Azerbaijan Highway Project

**Contracts CW2003-1 to Cw2003-4,
Rehabilitation and Upgrading of the Shemkir –
Gazakh Road Sections**

Review of tender documents

12 August 2003
Subject: Review of the Contracts CW2003 – 1 to CW2003 - 4

**Pictures taken at existing
bridge km 5+597**

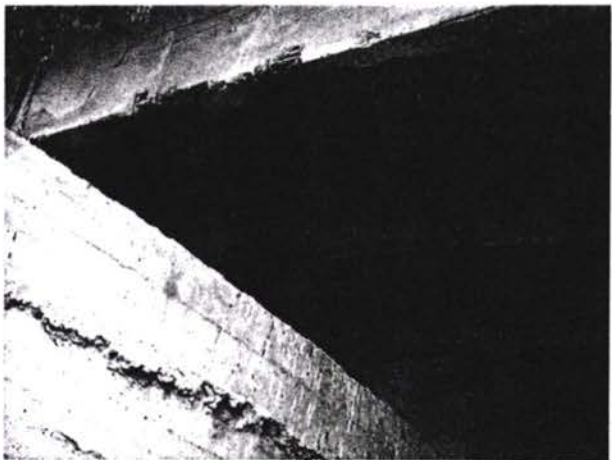
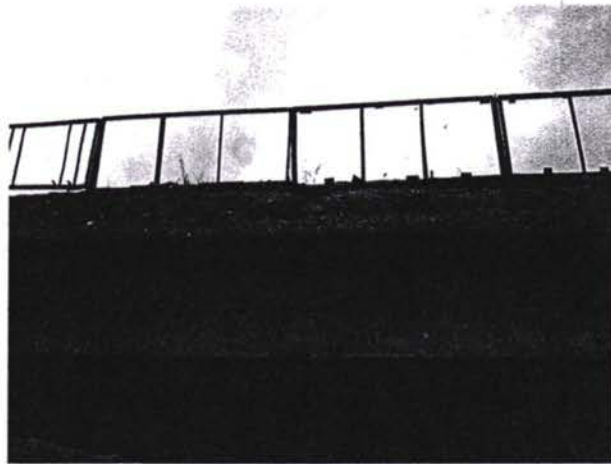
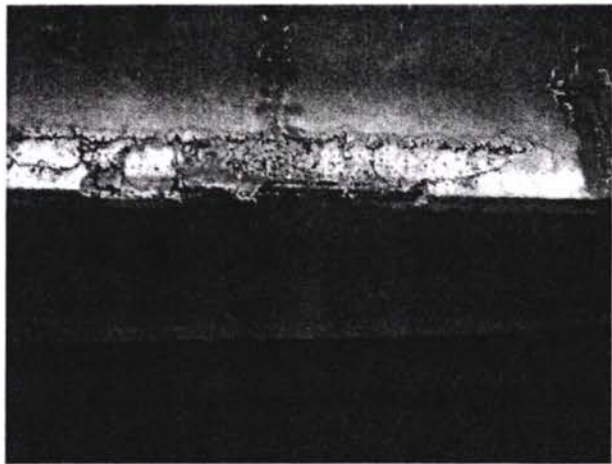
- Might be advisable to consider standard size span for the new structures instead a spectrum of all different size
- The existing bridge structure at km 5+597 scheduled for repair works by the bidding documents it looks quite worn down (see attached photos – attachment 3) and might be considered for partially or full replacement. The lack of resources and time prevent us from further investigation. Independent expert to be employ and review the structure or

as soon as the prospective Contractor start work the required test can be done and proper advise can be provided.
